I/A Series®
Retrofit Kit for GCIO Touchscreen Controller PWA

Kit Part Number: AG100VK

Purpose

Figure 3. PWA Positions in GCIO Units

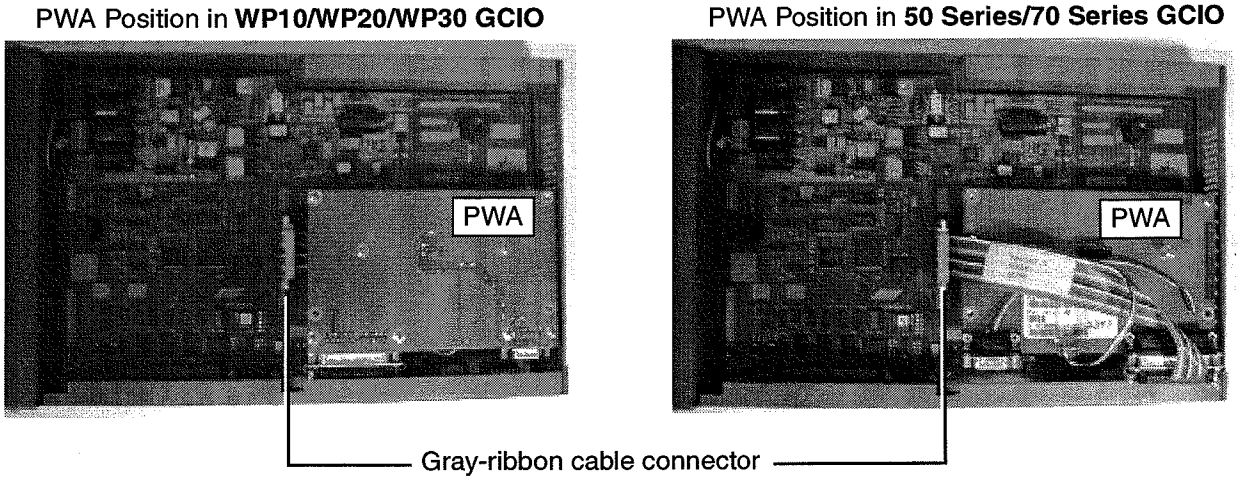
In WP10/20/30 types of GCIOs, the PWA is mounted upside-down.
   In 50 Series/70 Series types of GCIOs, the PWA is mounted right-side up.
   This is shown in Figure 3.

5. Unplug the gray ribbon-cable connector from the motherboard (see Figure 3).
6. Remove the four mounting screws from each corner of the PWA.
7. Remove PWA. You may discard or save this PWA, in the event that the GCIO may later be used to interface with CRTs of an earlier model than those listed in Table 1.

8. Mount the new PWA (P0922AA) in the GCIO in the same position as its predecessor.
9. Plug the gray ribbon-cable connector into the motherboard (see Figure 3).
